VC & UAB at the Fort Fisher State Historic Site

CM Clarification #3

Project: **Visitor Center & Underwater Archaeology Building
At the Fort Fisher State Historic Site**

LPILE Analyses

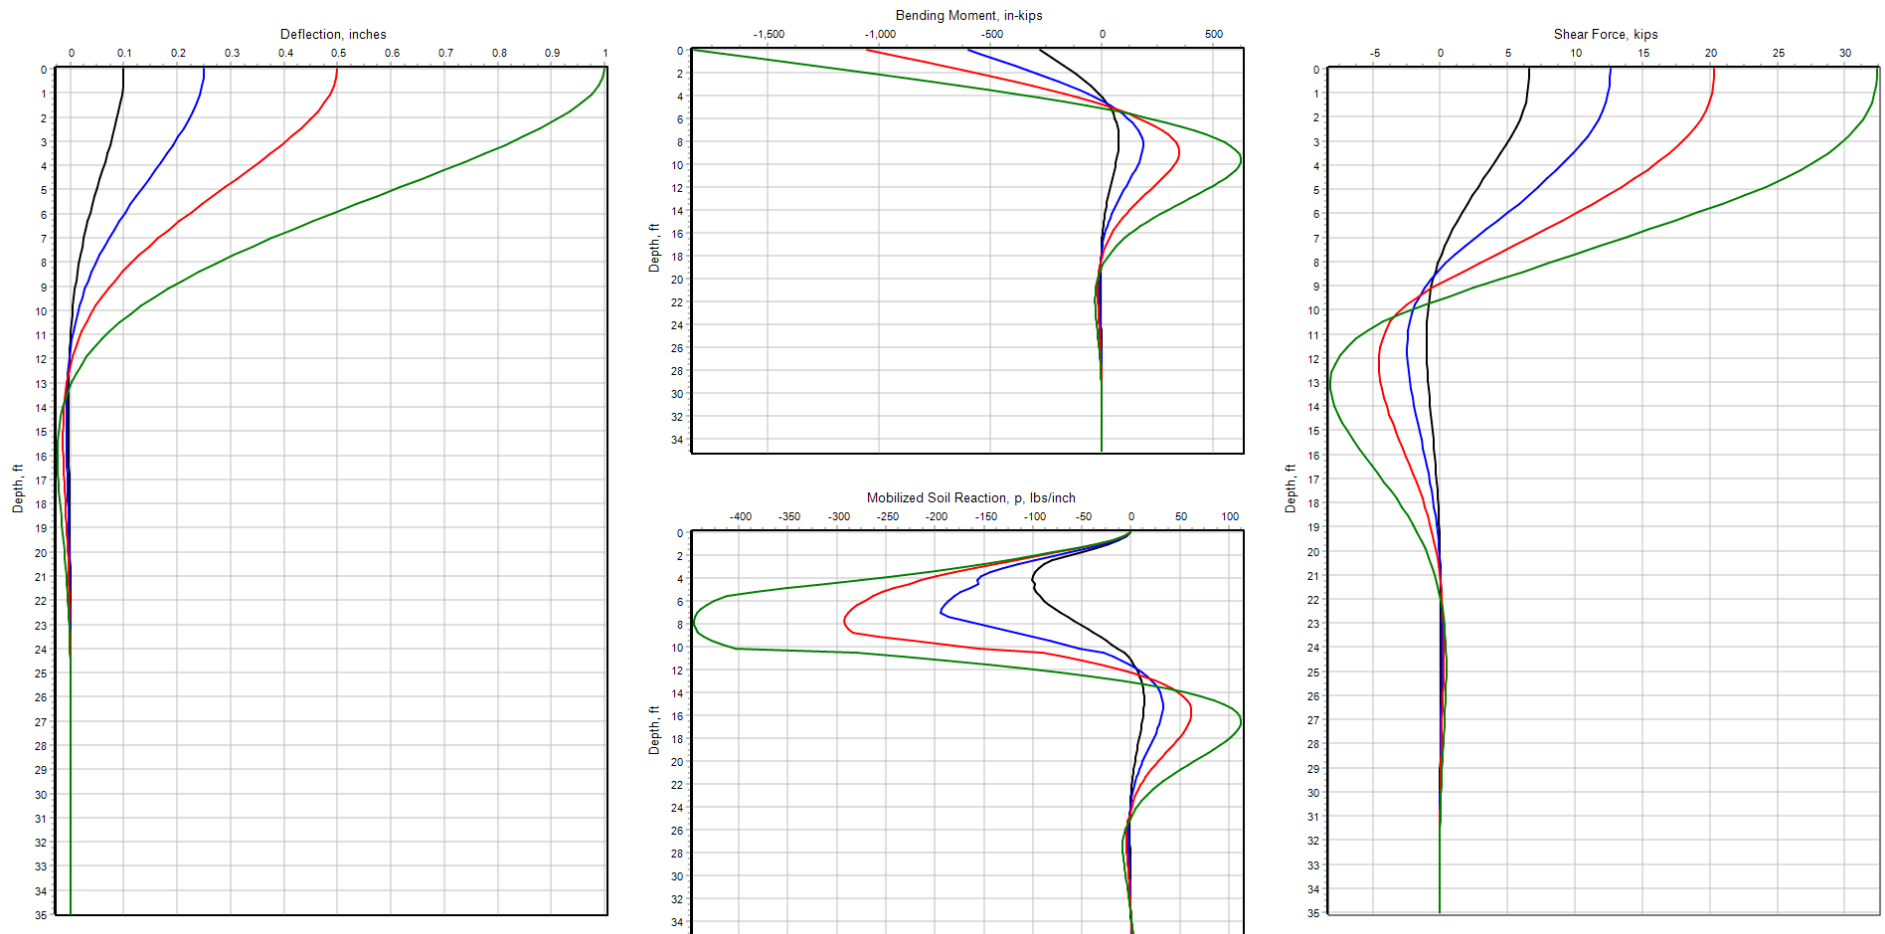
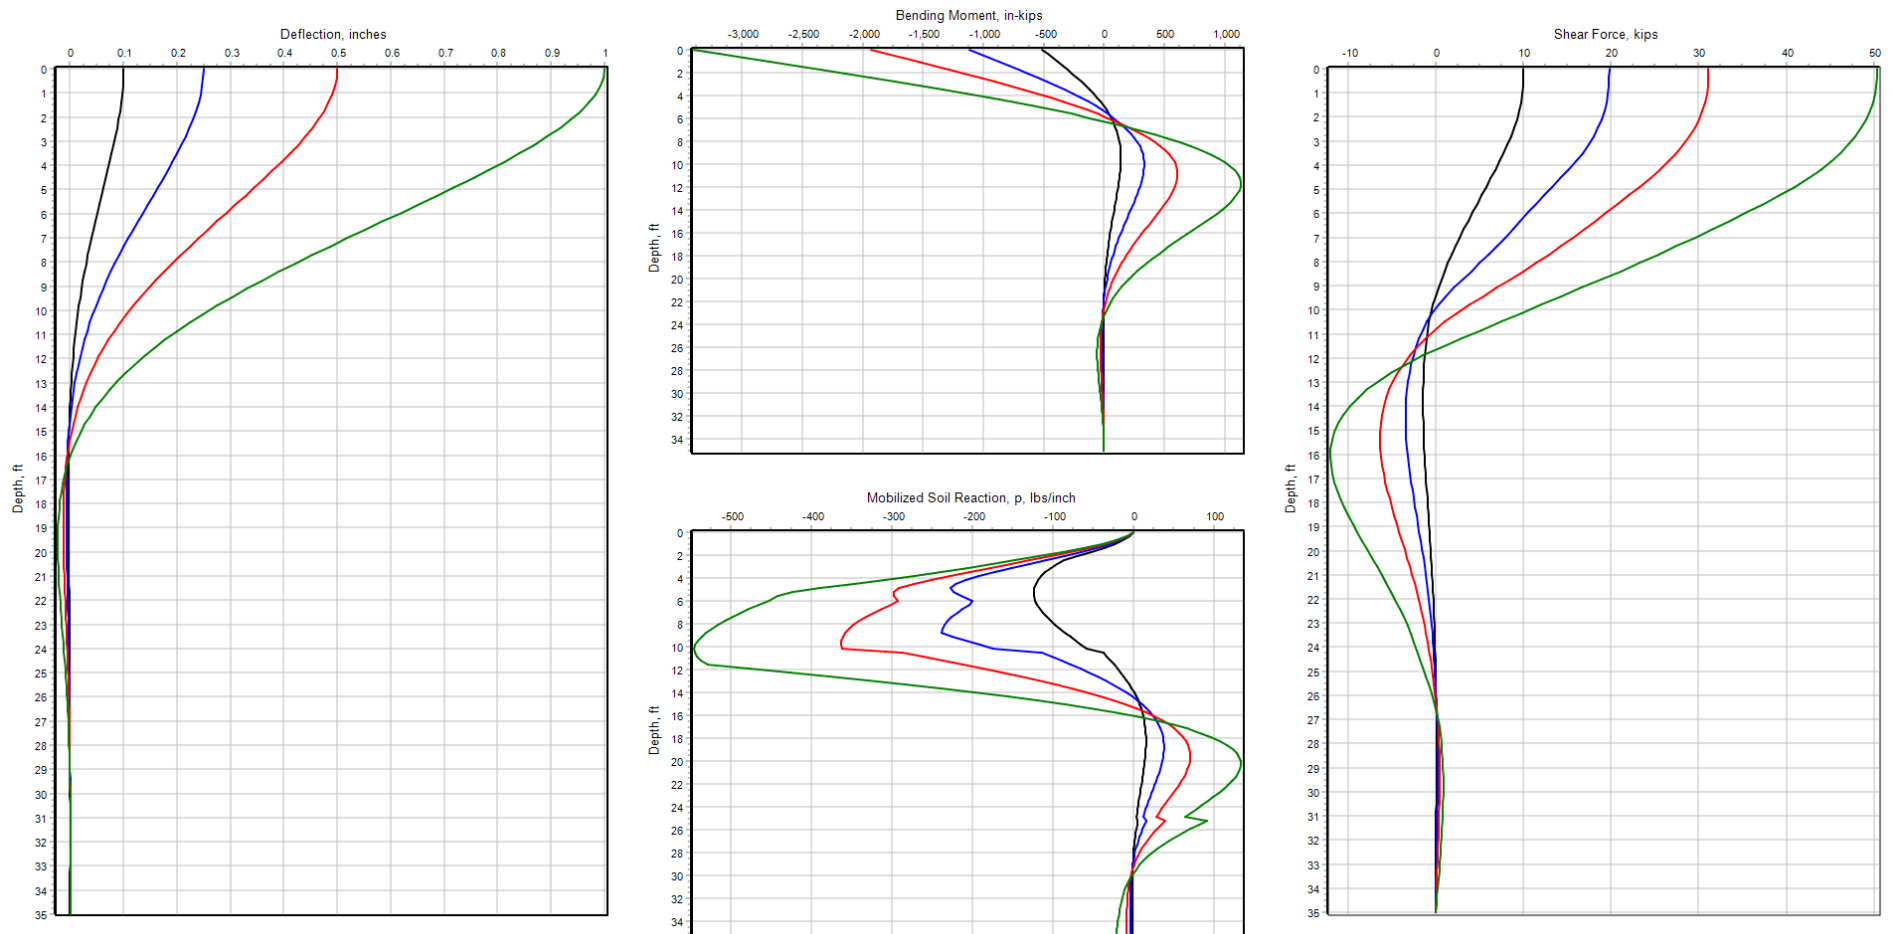
- CM Response:** Sketch is transmitted thru this CM Clarification; length of reinforcing is 60'
- RFI inquiry:** Drawing S-002, ACP Note #1: Please provide referenced Pile Loading Analysis Results Report dated August 04, 2020

- CM Response:** Report transmitted via this CM Clarification
- RFI inquiry:** Please confirm the following understanding is correct: Geotechnical Engineer is responsible for geotechnical design of the piles; Contractor is responsible for the structural design of the piles

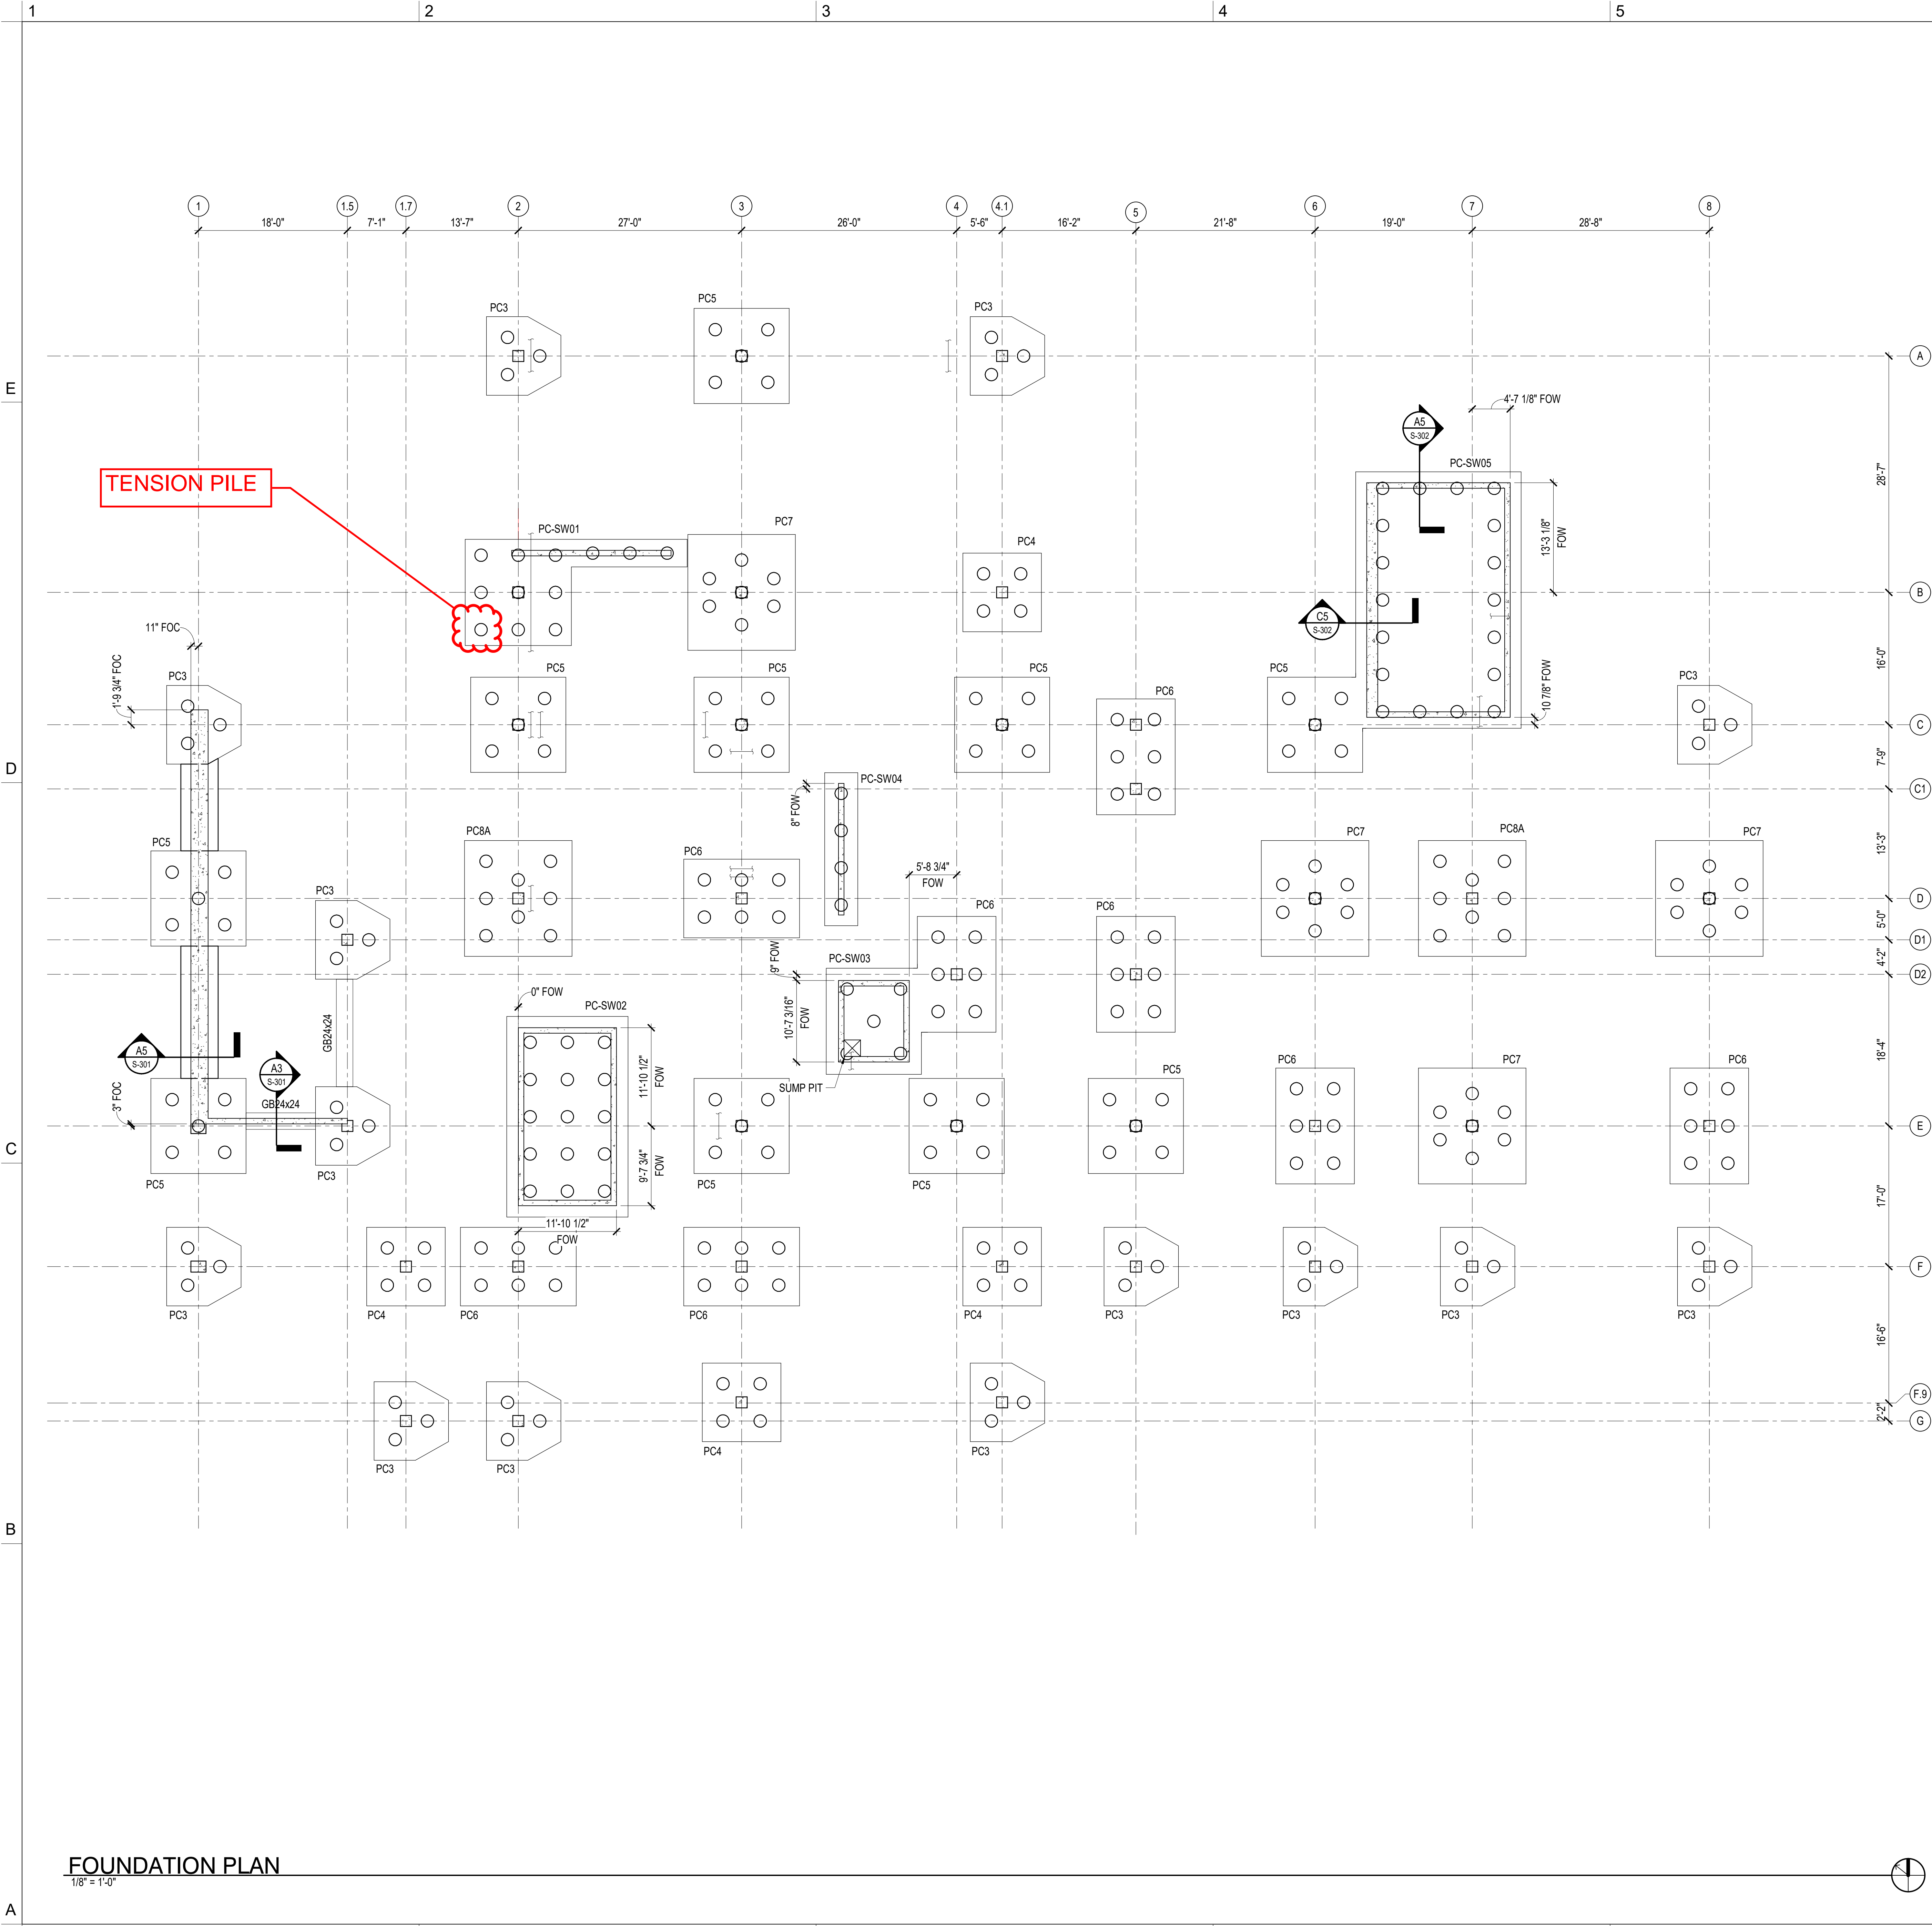
- RFI inquiry:** Drawing S-002, ACP Note #4: Please confirm location of all tension piles.
- CM Response:** Sketch is transmitted thru this CM Clarification
